Access Compliance Report

Public Rights-of-Way

(Pedestrian Signals)

Intersection ID: N/A	Main Street:	Cross Street: N/A	Location: N/A
ADA ID: 432F0101597F	Signal Type: Two Push Buttons-APS	Overall Compliance: No	Severity Score: BTN 1:N/A BTN 2: N/A No BTN: N/A
Codes/Mitigation Info/Possible Solution		Field Measurements/Component Compliance

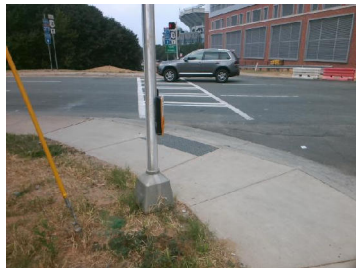
Surveyor Notes: NO BUTTON PRESSURE
BTN 1, BUTTON NOT WORKING

PROW/ADA: R410.6, TMUTCD 4e.08, R404.2, R404.3, R406.2, R404.7.3, R403.4, R209.1, TMUTCD 4e.10, MUTCD 4e.08, R104.2,

Possible Solutions: Replace Signal Push Button With APS Button on New Post. Remove & Replace Sign.
